2 NUCLEAR REGULATORY COMMISSION

4 ADVISORY COMMITTEE ON REACTOR SAFEGUARDS

6 SUBCOMMITTEE ON PLANT LICENSE RENEWAL

This is a meeting of the Plant License Renewal Subcommittee to review the Indian Point Units 2 and 3 license renewal application.

Figure 2.5-2

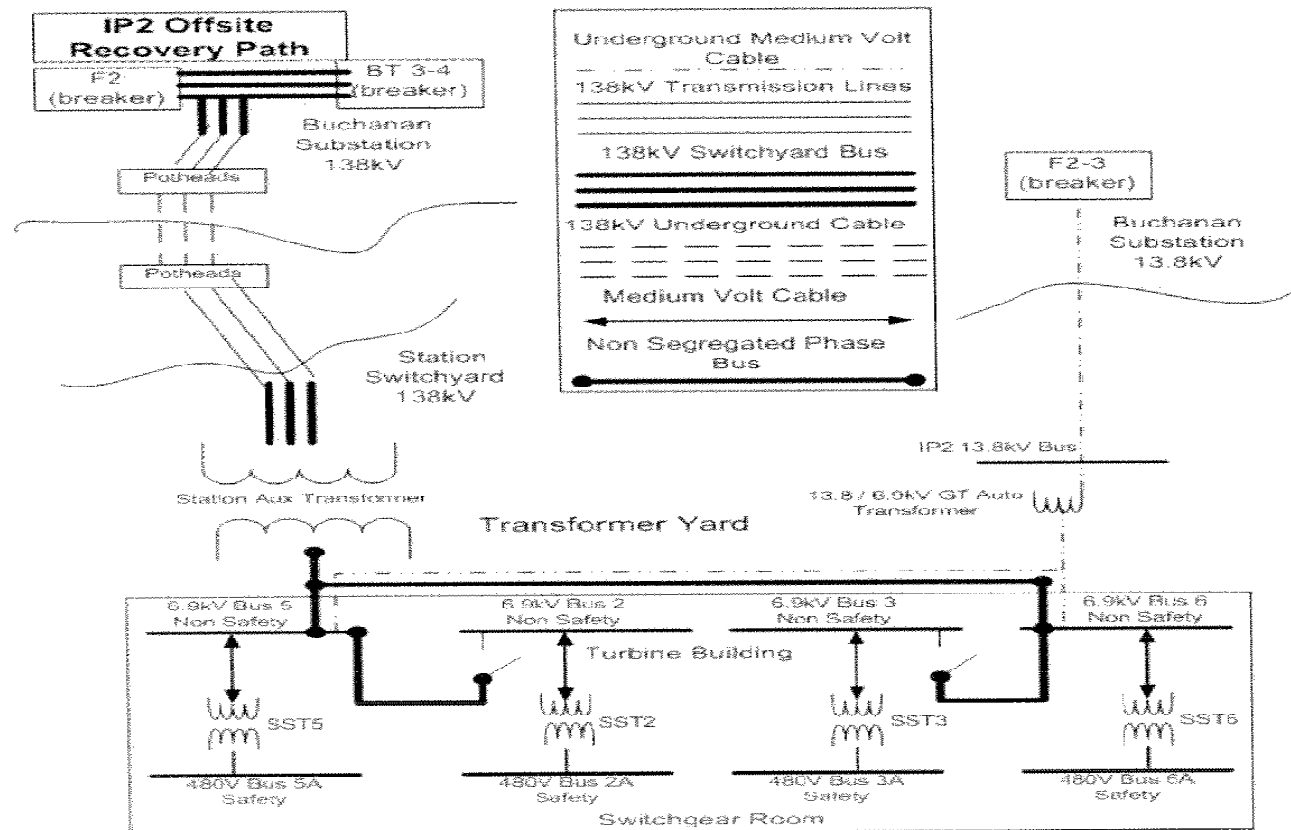
- OI 2.5-1 – SBO scoping
 - Applicant revised LRA Figures 2.5-2 and 2.5-3, the “Offsite Power Scoping Diagram(s)” for IP2 and IP3 for primary and secondary offsite power paths
 - By letters dated March 24, 2008 and August 14, 2008, the applicant revised and clarified its response
 - The staff is completing its review of the applicant’s information on the SBO scoping boundary and will document its conclusion in the final SER
